City of Madison

# Complete Green Streets Guide

## Transportation Commission Review

September 4, 2024

# Equity Priority Areas - Recommendation

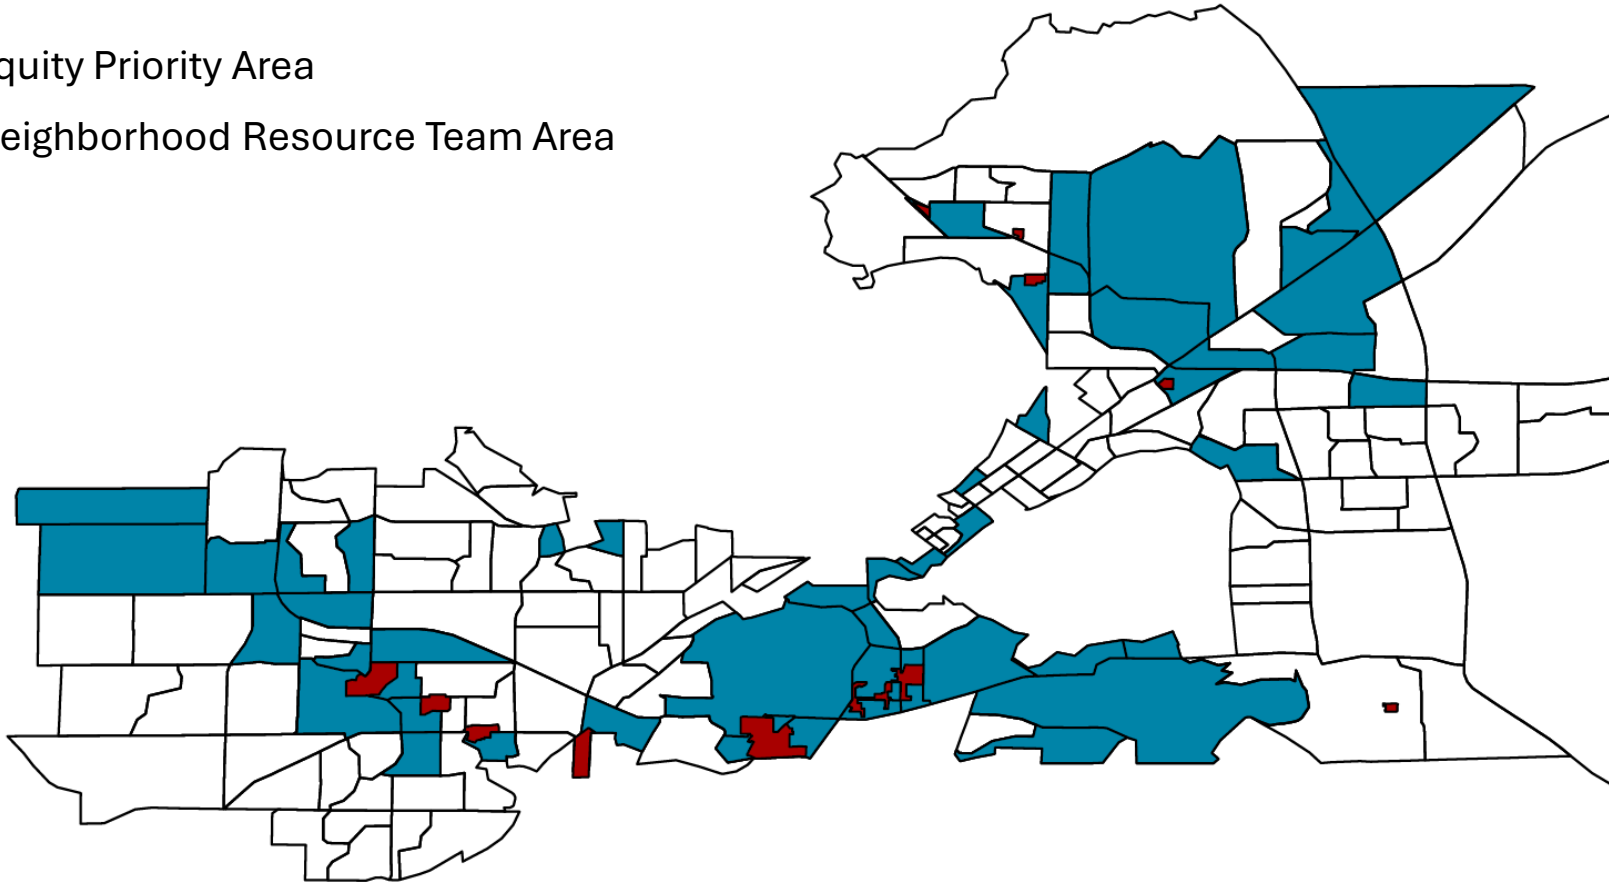
- Approved Guide calls for expanding this Overlay
- Align with City Equity Areas
  - Align with Transportation Improvement Program scoring

- Equity Priority Area
- Neighborhood Resource Team Area

- Update Equity Priority Areas using new city map
- Update Boulevard description to add “Feature tree lined sidewalks, terraces and medians.”
- Changes to 6.1 Design Parameters table

### Option 1 - Limit parking to one side of street

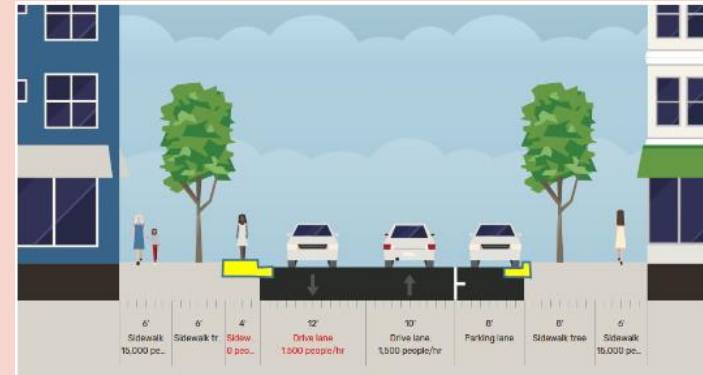
- Include a 4' paved terrace
- Include a 4' rolled curb

- Signs and light poles would be allowed in terrace
- Verify 4' curb works with storm management plan
- Sow plowing of terrace will be responsibility of property owner, not City.

### Option 3 - Limit parking to one side of street

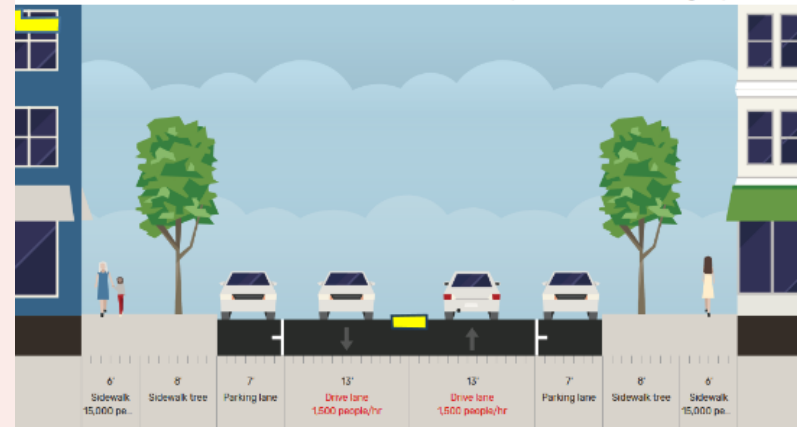
- Include a 4' curb pan
- Similar to Option 1. Can be used if stormwater management plan requires full curb head

### Option 5 – Limit parking to one side with back in angled parking

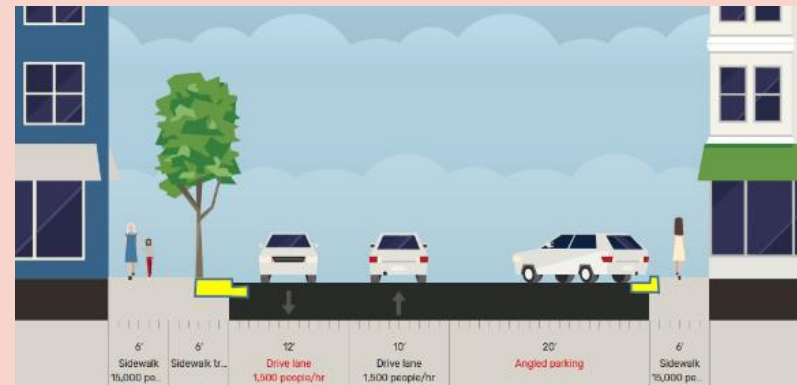
- Include 4' paved terrace
